**GENOA CHARTER TOWNSHIP
PLANNING COMMISSION
PUBLIC HEARING
FEBRUARY 13, 2023
6:30 P.M.
AGENDA**

Attention:	Amy Ruthig, Planning Director
Subject:	Wonderland Marine – Special Land Use and Site Plan Review #3
Location:	5796 Grand River Avenue – south side of Grand River, west of Dorr Road
Zoning:	GCD General Commercial District and TCO District Town Center Overlay District

**Re: Wonderland Marine Showroom
Site Plan Review No. 2**

**WONDERLAND MARINE WEST
Genoa Township, Michigan
Site Plan Application**

SIDEWALK CROSS SECTION
NOT TO SCALE

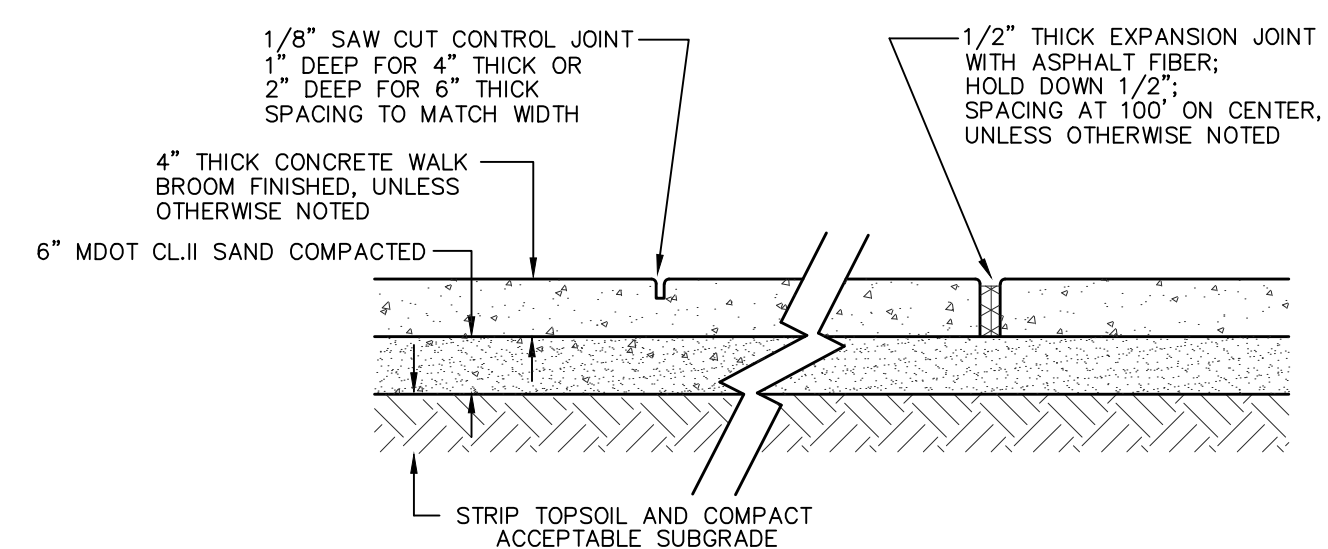
1. The sidewalk cross section should be updated to show six inches of MDOT CLII sand subbase.
2. The Livingston County Drain Commissioner (LCDC) requires that the "Land Use Summary Table" found in Appendix J of their updated LCDC Procedures and Design Criteria for Stormwater Management Systems be included on the cover sheet of the construction plans.

1. The sidewalk cross section should be updated to show 6 inches of MDOT CLII sand subbase.

DESIGN: WMP	REVISION #	DATE	REVISION-DESCRIPTION	REVISION #	DATE	REVISION-DESCRIPTION
DRAFT: JHG	1	11-21-22	REVISED PER REVIEW COMMENTS			
CHECK: WMP	2	2-9-23	REVISED SIDEWALK CROSS SECTION DETAIL

NEW HIGH BAY BOAT SHOWROOM For:
WONDERLAND MARINE WEST
GENOA TWP., MI
ELEVATIONS

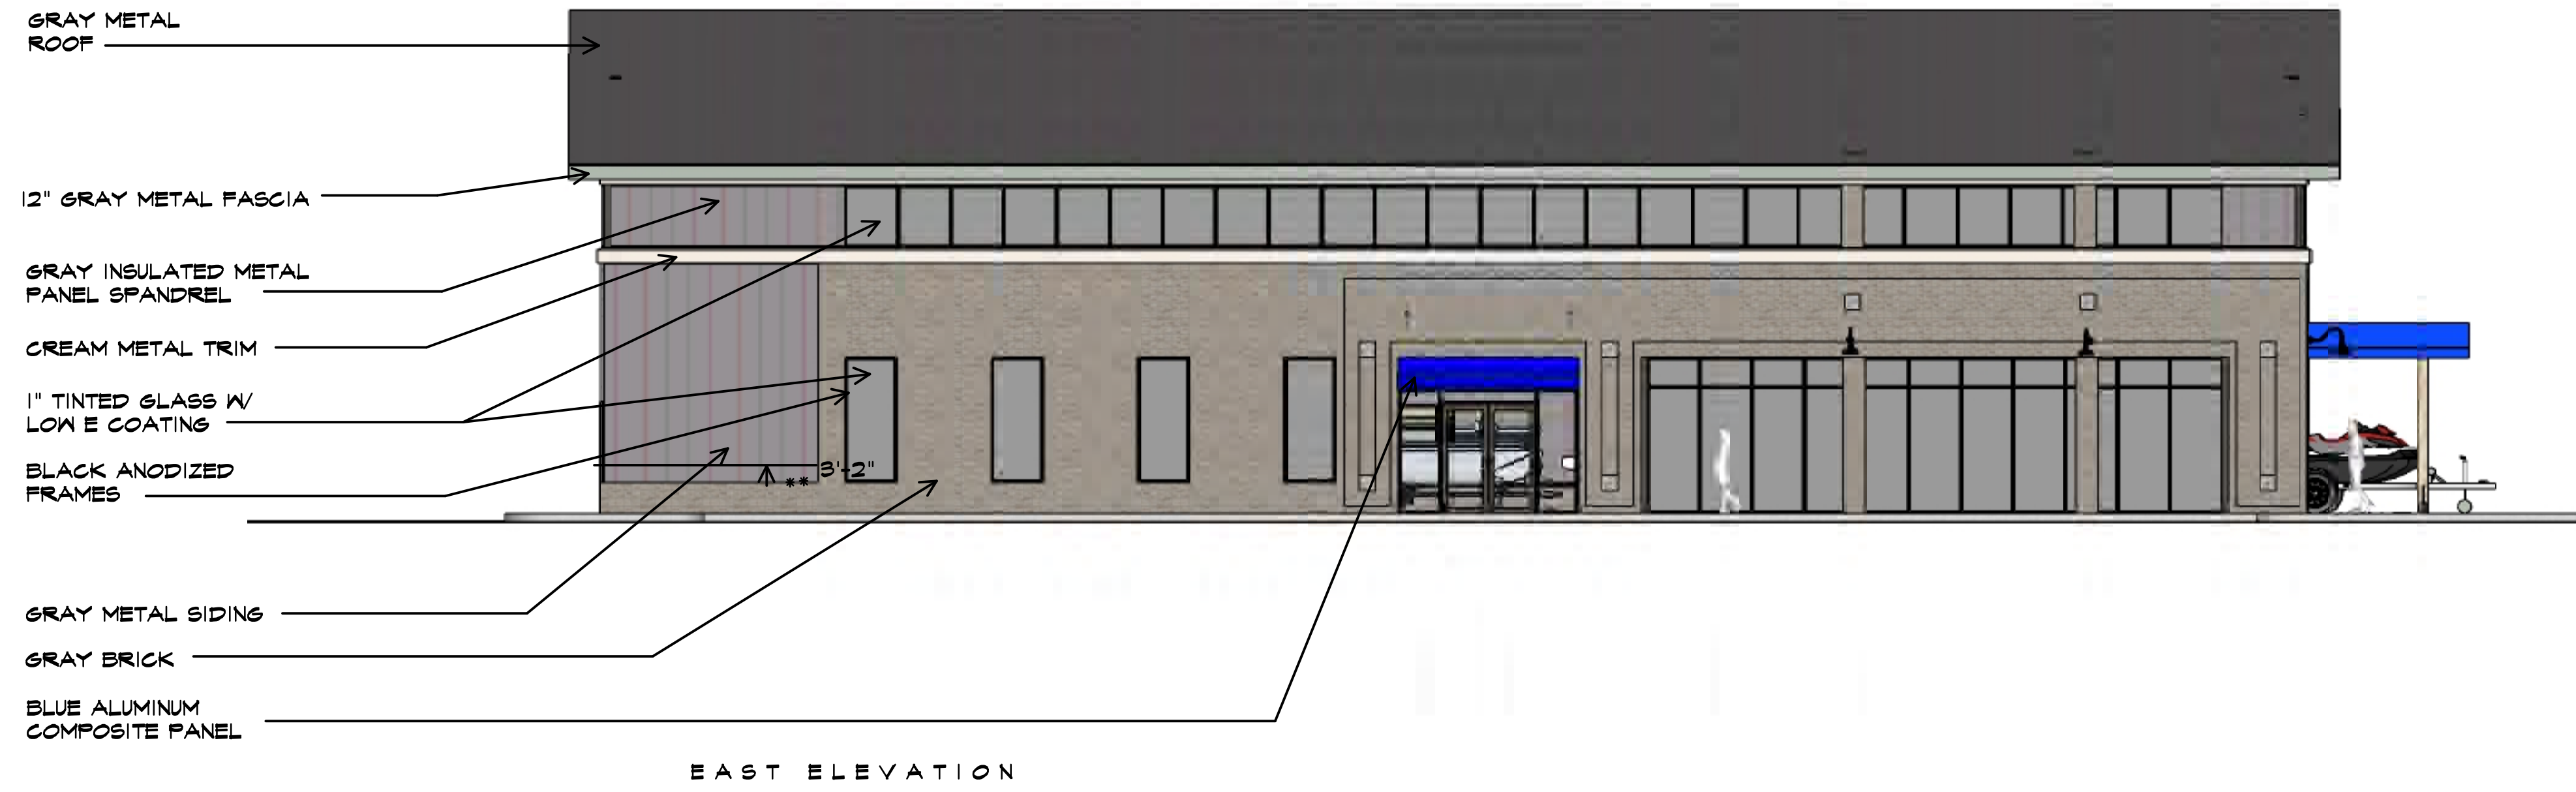
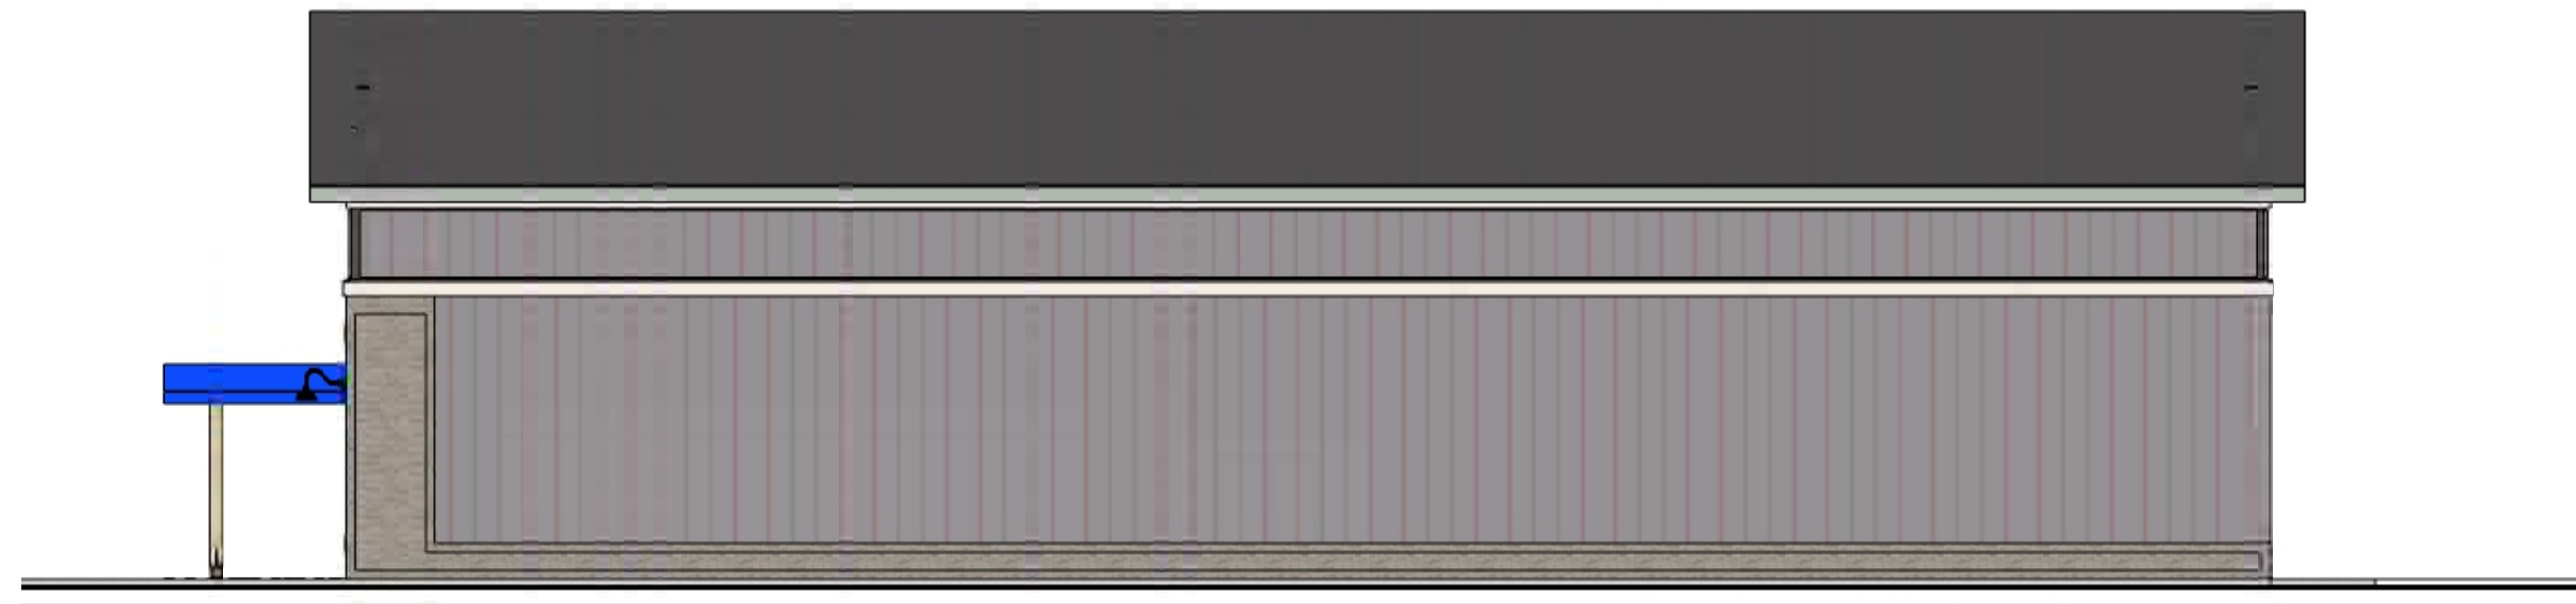
3. Site Plan Review:
- a. The proposed parking does not fully comply with the dimensional requirements of Section 9.04.01.
 - b. The proposed building does not fully comply with the architectural requirements of Section 9.05.01. Per Section 9.05.03, the Township may modify these requirements.

**
RAISE BRICK BASE
12" THIS AREA TO 3'-2" EL. FOR
75% BRICK PERCENTAGE
